July 11, 2016

RE: Austin Oaks TIA – TIA Comment Response

Traffic Engineering and Arterial Management Division staff comments received 7/1/2016.

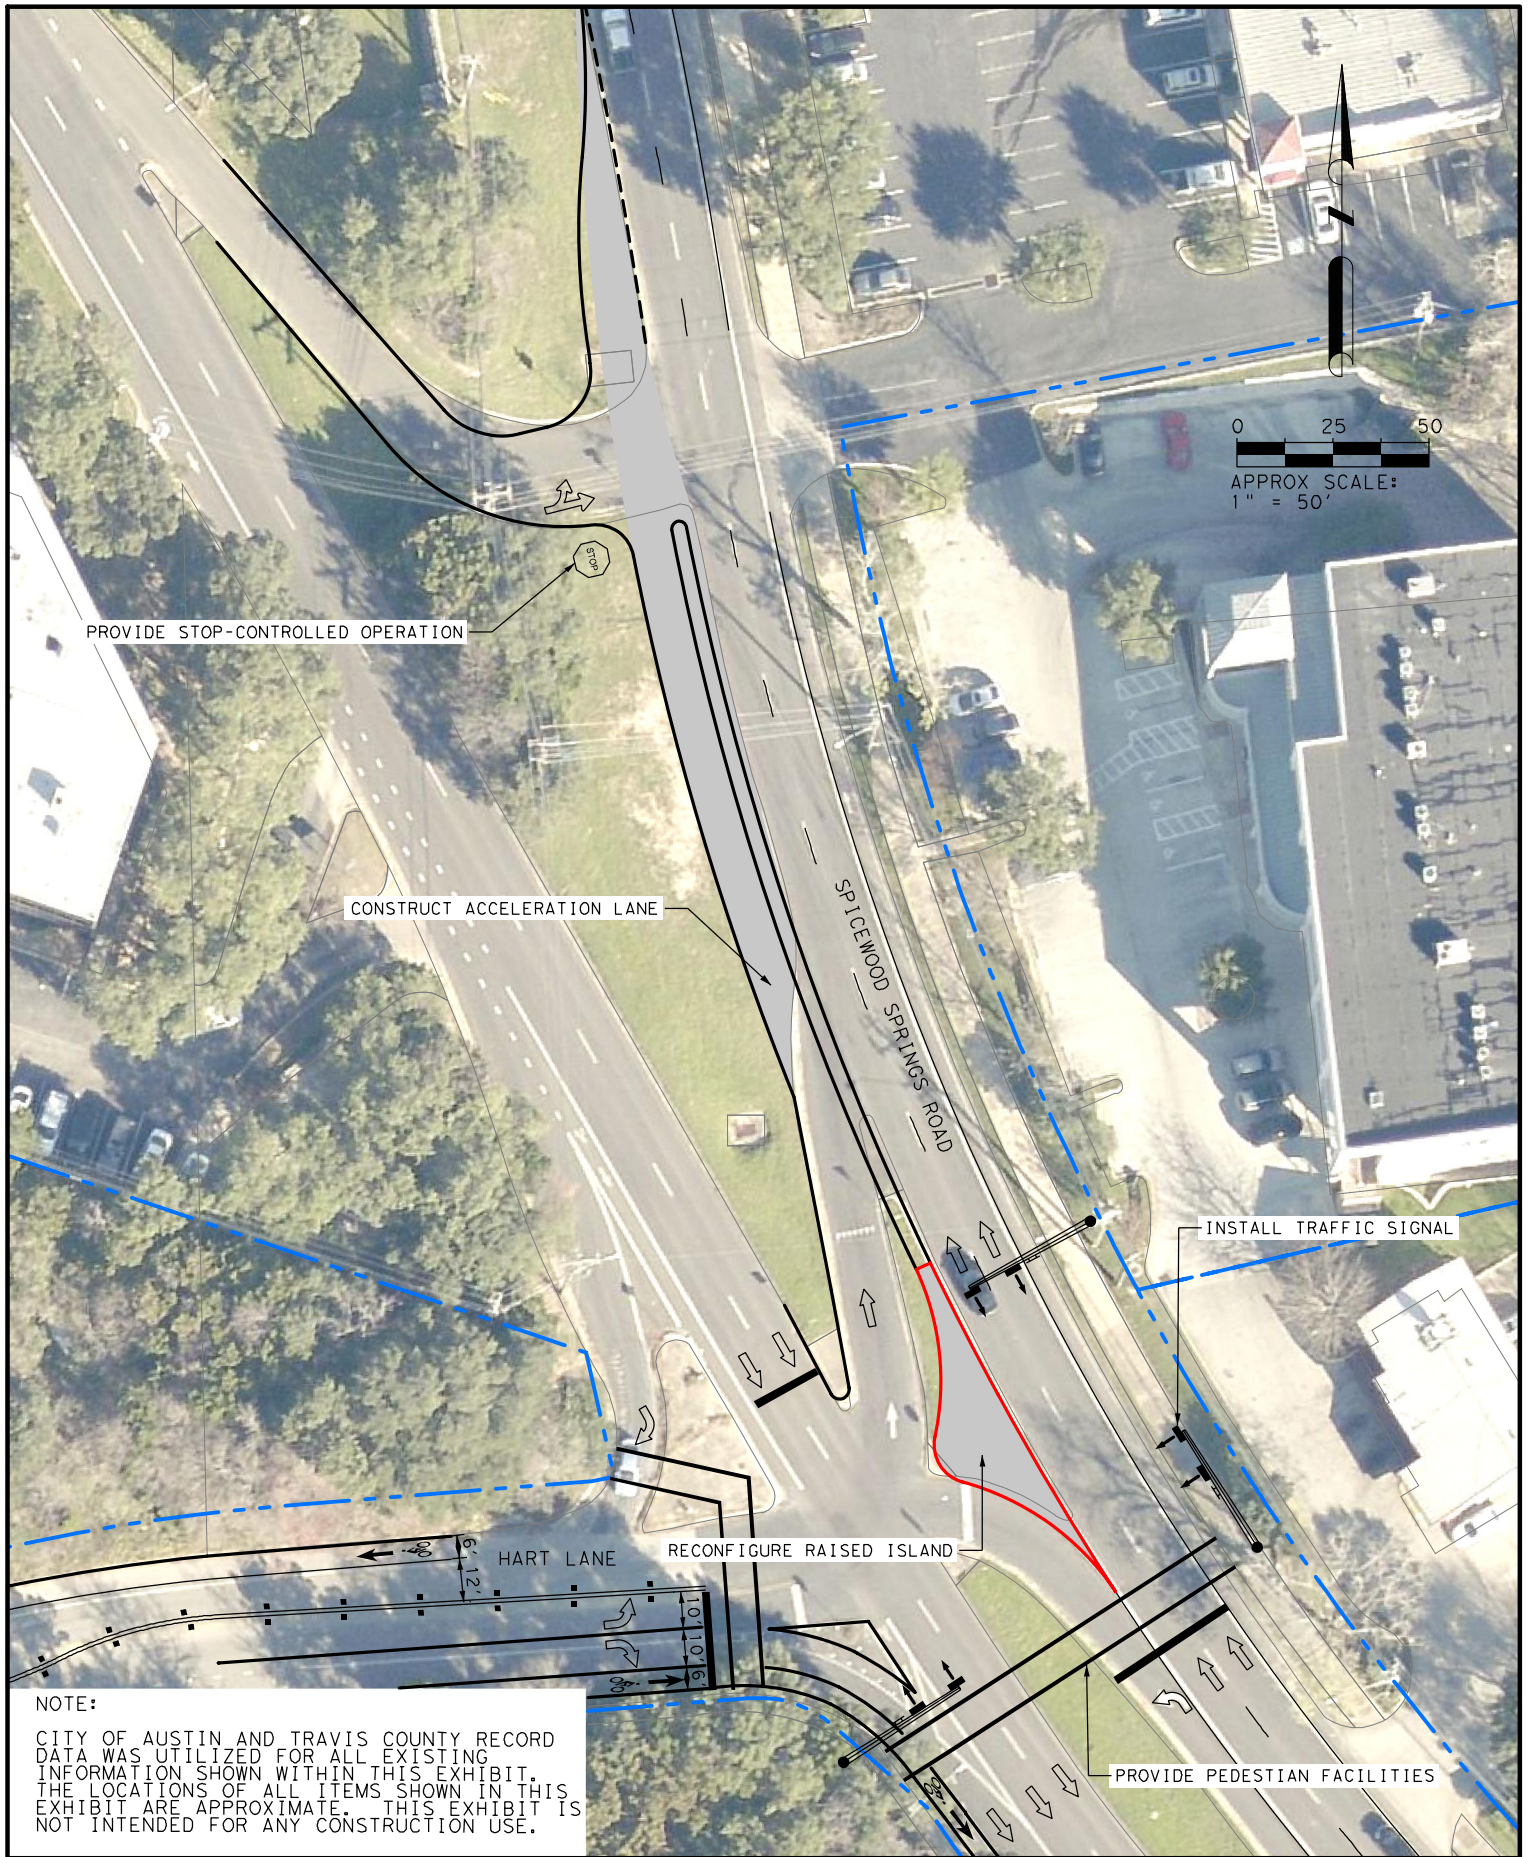
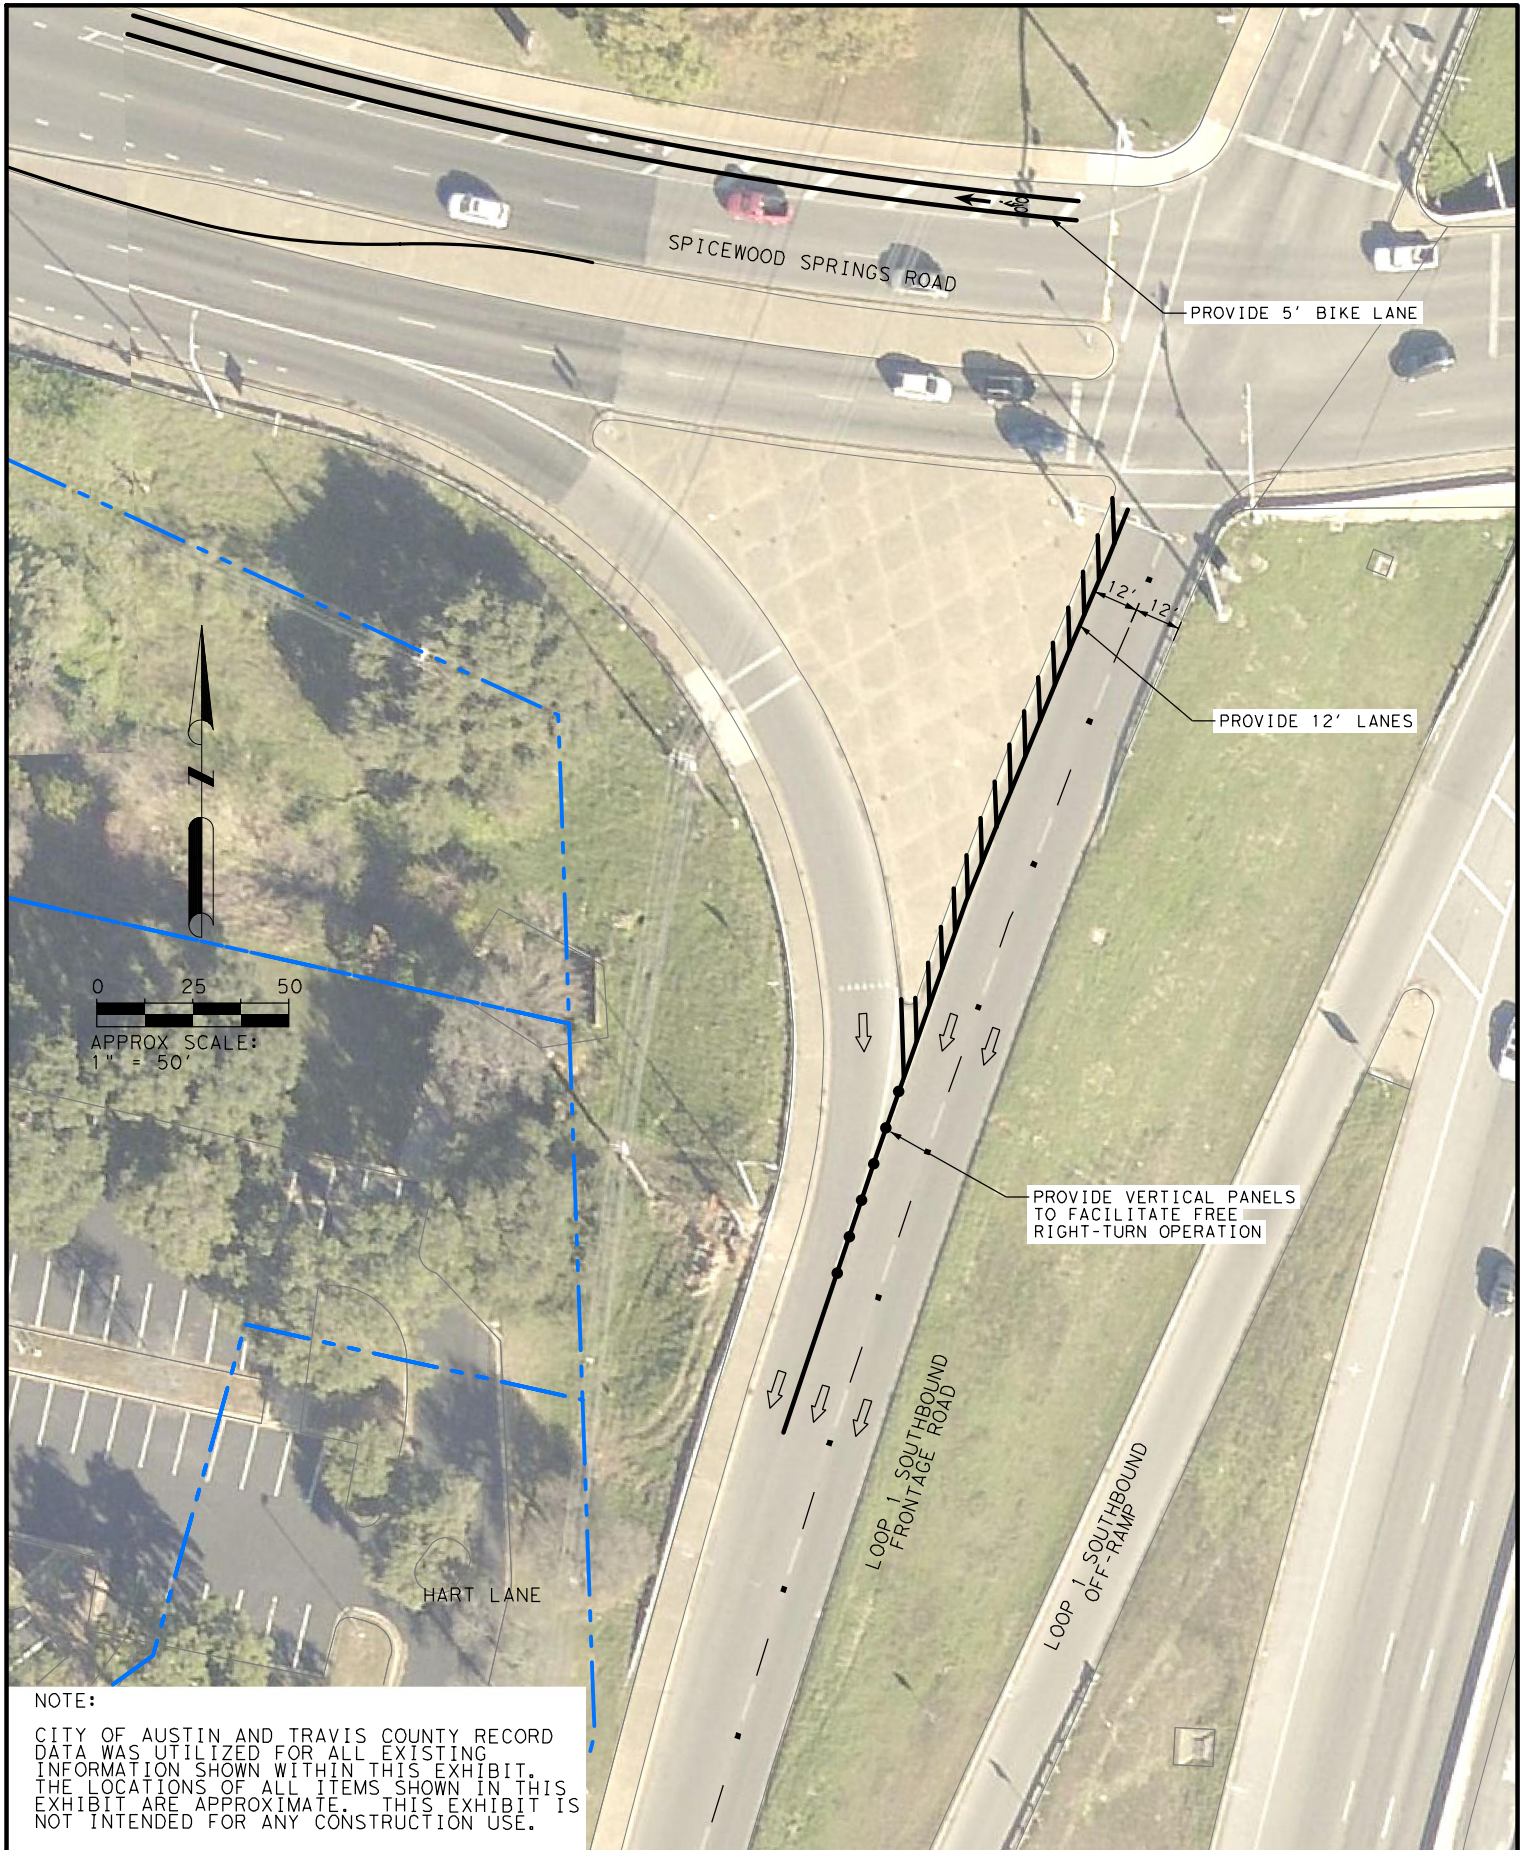
12. 2022 Exhibit A: Far West Boulevard & Wood Hollow Drive – None
13. 2024 Exhibit A: Executive Center Drive & Hart Lane – Provide lane alignment along Hart Lane through the intersection of Executive Center Drive' Provide bike lanes along Hart Lane and Executive Center Drive.

Response: See *Attachment*.
